MFN 09-007

**Subject: Response to Portion of NRC Request for Additional Information Letter No. 253 Related to the ESBWR Design Certification – Licensing Topical Report (LTR) NEDO-33337 “ESBWR Initial Core Transient and Accident Analyses – RAI Numbers 15.2-50 and 15.2-52**

**LTR NEDO-33337 ESBWR Initial Core  
Transient and Accident Analyses**

**RAI Numbers 15.2-50 and 15.2-52**

**Figure 2.3-5h. Generator Load Rejection with a Single Failure in the Turbine Bypass System (fig a from 0 to 5s)**

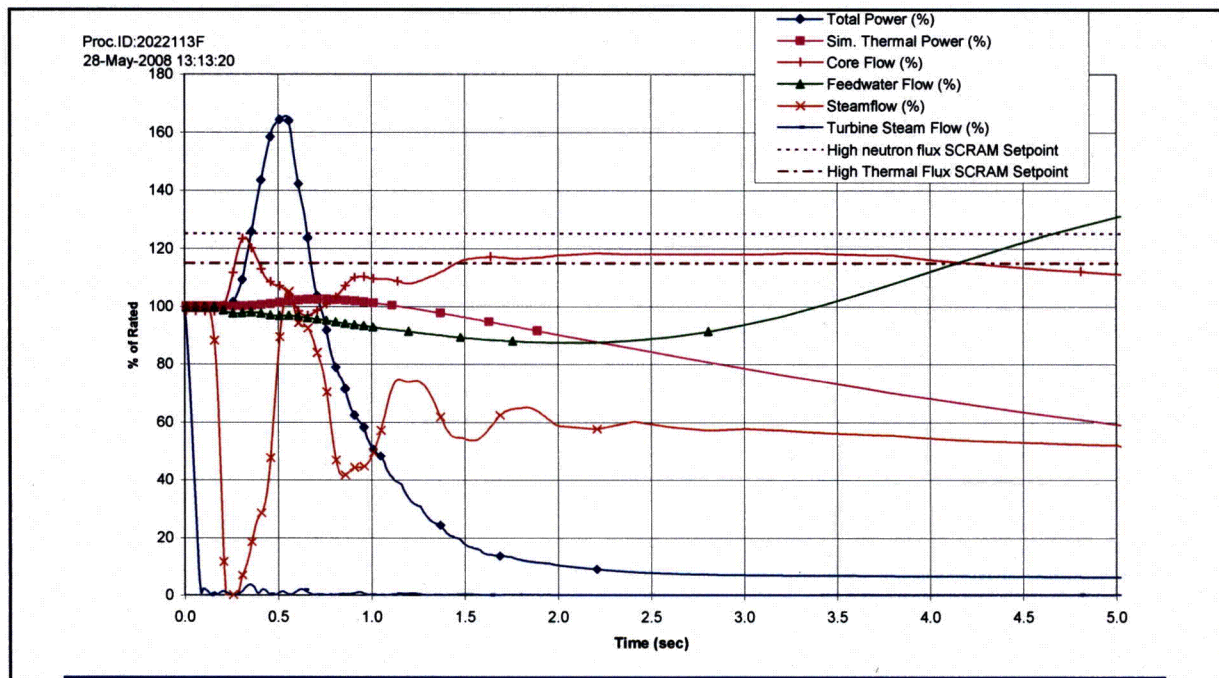
*NEDO-33337, for those transients with rapid changes in the early portion (e.g.,  $t = 0$  seconds to  $t = 1$  or 2 seconds), provide additional plots with expanded scale. plots with expanded scale. Also provide the energy deposition and peak cladding temperature for those cases where the core flow is very low.*

- Generator Load Rejection with Single Failure in the Turbine Bypass System - Fig 2.3-5h (expanded "a" plot)
- Generator Load Rejection with Single Failure in the Turbine Bypass System - Fig 2.3-5i (expanded "f" plot)
- Turbine Trip with Turbine Bypass - Fig 2.3-6h (expanded "a" plot)
- Turbine Trip with Single Failure in the Turbine Bypass System - Fig 2.3-7h (expanded "a" plot)
- MSIV Closure - Fig 2.3-9h (expanded "a" plot)
- MSIV Closure - Fig 2.3-9i (expanded "f" plot)
- Loss of Condenser Vacuum - Fig 2.3-10h (expanded "a" plot)
- Opening of One Turbine Control or Bypass Valve - Fig 2.3-14h (expanded "a" plot)
- Loss of Non-Emergency AC Power to Station Auxiliaries - Fig 2.3-15i (expanded "f" plot)

It is noted that the "Generator Load Rejection with Single Failure in the Turbine Bypass System" event has been updated to be consistent with the updated steam line model used in the same analysis in the DCD. Figure 2.3-5h is from this updated analysis. The updated analysis does not include the updated TRACG channel pressure drop. This same TRACG analysis was re-performed with the model with the updated pressure

Figure 15.3-2a. Feedwater Controller Failure – Maximum Flow Demand

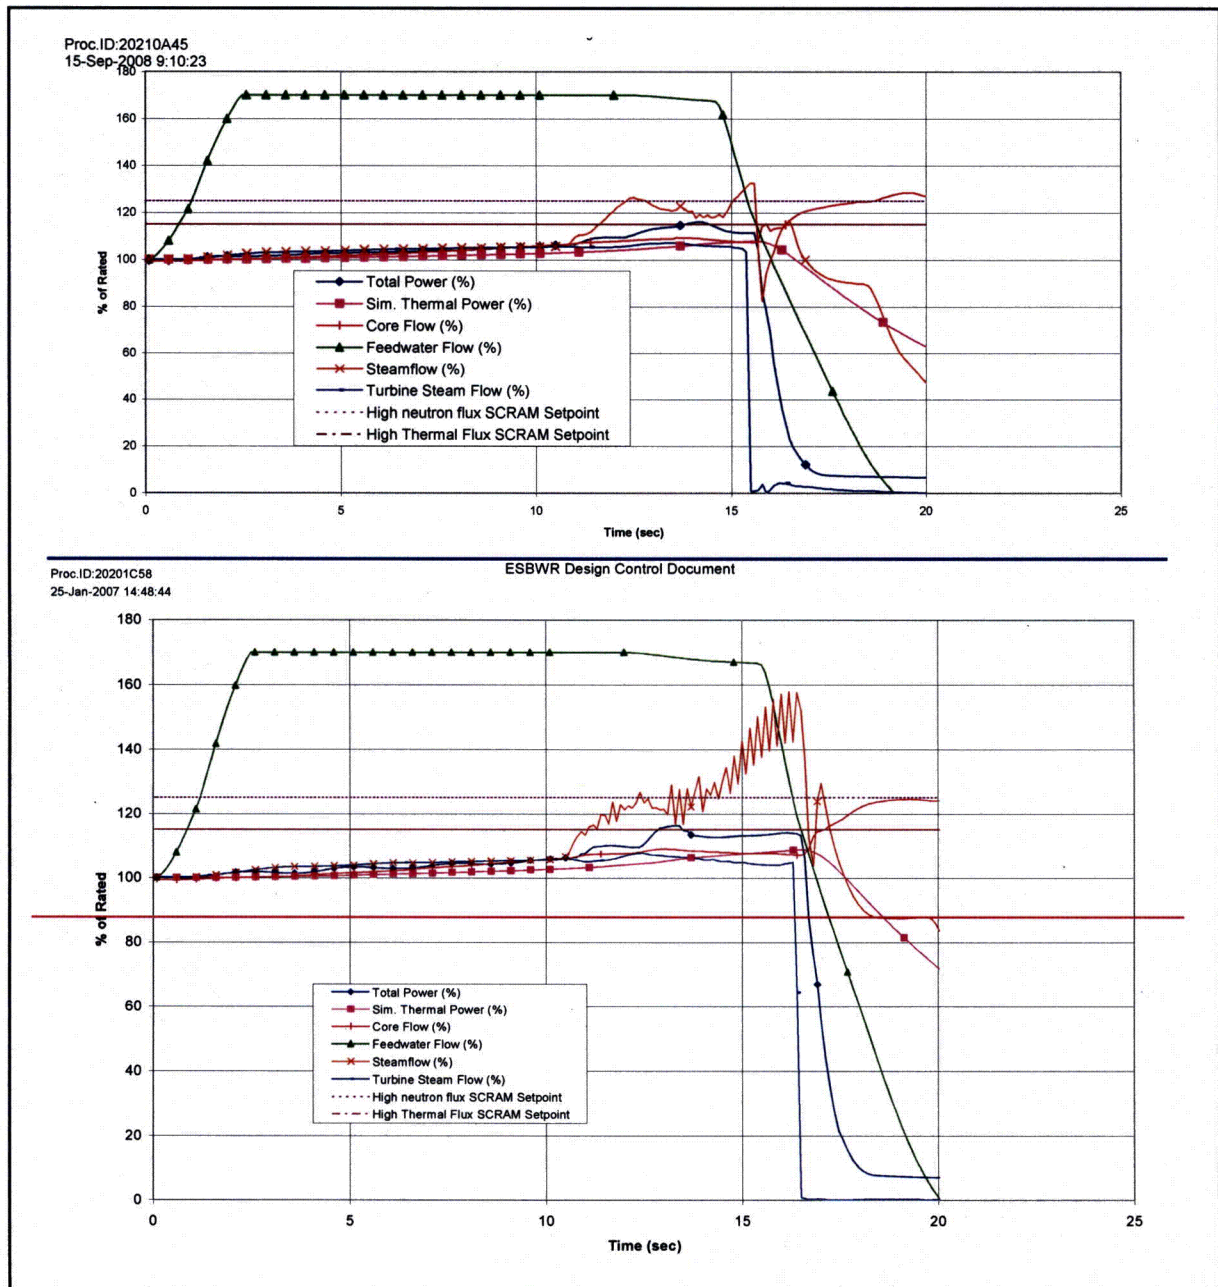
*Explain whether the equilibrium core steam flow rate oscillation is numerical or physical compared to initial core steam flow rate for the feedwater controller failure, maximum demand transient. DCD, Tier 2, Rev 5, Figure 15.3-2a, for the Feedwater Controller Failure, (Maximum Demand transient), the equilibrium core steam flow oscillates significantly, while the initial core steam flow shown in Figure 2.4-2a of NEDO-33337 does not. Explain whether the oscillation is numerical or physical.*

The equilibrium core steam flow oscillation is not the expected behavior of the steam flow rate, rather it is a numerical TRACG behavior. The cause of the difference is the hydraulics time step. The equilibrium core analysis allows a maximum time step of 0.05 seconds; whereas, the initial core analysis limits the maximum time step to 0.005 seconds. The smaller time step in the initial core analysis results in a smoother steam flow plot.

The analysis in the DCD for the equilibrium core is recalculated using a 0.005-second maximum time step consistent with the initial core analysis. As expected, the oscillations are reduced, and there is no change in the  $\Delta$ CPR result. Figures 15.3-2a through 2g and Tables 15.3-1a and 15.3-3 will be updated for the DCD Tier 2, Rev 6 as shown in the attached. The numbers in legend of Figure 15.3-2g represents channel groups in TRACG. The TRACG channel grouping map is shown in Figure 15.2-50-1.

DCD Tier 2, Figures 15.3-2a through 15.3-2g and Tables 15.3-1a and 15.3-3 will be revised as noted on the attached markup.
